fADC125 – 27 May 2009

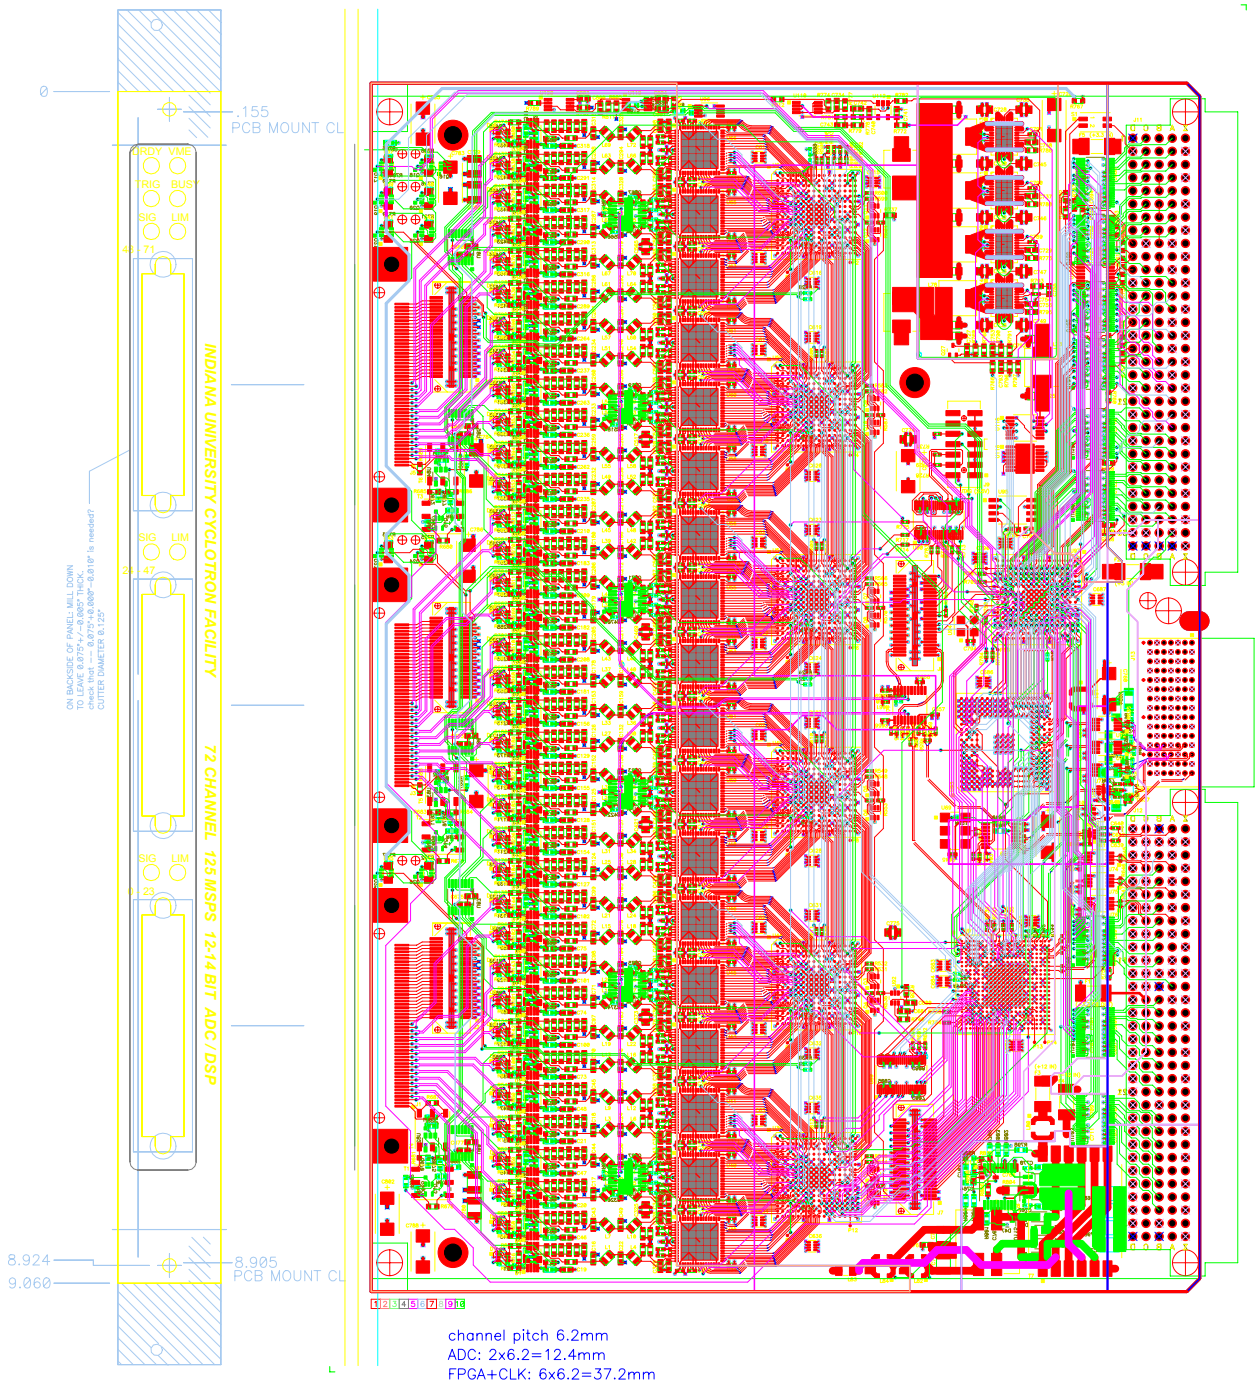
HEY– DON'T FORGET THE HANDLE/PANEL HOLES!!!
– DON't FORGET THE GND–CONNECTOR R–C TIES 3 pl. !!
// AND MOST IMPORTANT: LOOKS LIKE WE NEED TO HAVE THE PANEL MILLED OUT FROM REAR TO 2.0 mm THICK, AND PLAY SAME GAME AS ON LLRF BOARD (EXTEND FRONT EDGE OF BOARD EXCEPT NOT IN HANDLE ATTACH AREA)
–– WATCH FOR ANY CLEARANCE ISSUES WITH BOTTOM COMPONENTS AND THE EMI EDGE (PROBABLY NONE)
